# Access Compliance Report

## Public Rights-of-Way

### (Curb Ramps)

Intersection ID: 29158	Main Street: RIDGE_RD	Cross Street: HIGHLAND_PARK_DR	Location: E
ADA ID: 4FE4D8D57B01	Ramp Type: Perp	Initial Pass/Fail: Fail	Overall Compliance: No
		Severity Score: 8.75

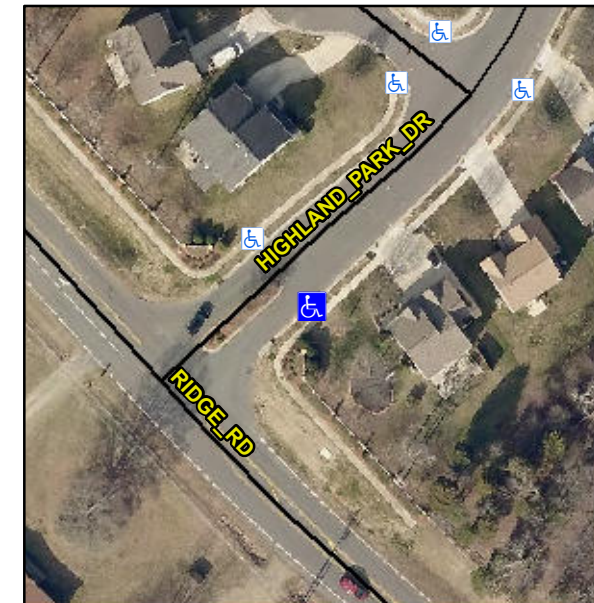
**R304.5.1**

Compliance	Description	Data	Compliance	Description	Data
N/A	Ramp Length (in)	49.5	Yes	Ramp Slope (%)	6.4
No	Ramp Width (in)	47.0	Yes	Ramp XSlope (%)	0.8
N/A	Flare Type LT	N/A	N/A	Flare Type RT	N/A
N/A	Flare Slope LT (%)	N/A	N/A	Flare Slope RT (%)	N/A
N/A	Flare Traversable LT?	N/A	N/A	Flare Traversable RT?	N/A
N/A	Landing Length (in)	N/A	N/A	DWS Provided?	N/A
N/A	Landing Width (in)	N/A	N/A	DWS Contrast?	N/A
N/A	Landing Slope (%)	N/A	N/A	DWS Length (in)	N/A
N/A	Landing X Slope (%)	N/A	N/A	DWS Full Width?	N/A
N/A	Landing Curb? (Y/N)	N/A	N/A	DWS Offset (in)	N/A
N/A	Shared Landing?	N/A			
N/A	Gutter Ponding?	N/A	N/A	Gutter Slope (%)	N/A
N/A	Gutter Lip Ht (in)	N/A	N/A	Gutter X Slope (%)	N/A
N/A	Painted X Walk1?	No	N/A	Painted X Walk2?	N/A
	X Walk 1 Direction	To NW		X Walk 2 Direction	N/A
N/A	X Walk 1 Width (in)	N/A	N/A	X Walk 2 Width (in)	N/A
	X Walk 1 Slope (%)	3.3		X Walk 2 Slope (%)	N/A
	X Walk 1 X Slope (%)	1.5		X Walk 2 X Slope (%)	N/A

**Remove & Replace Entire Ramp.**
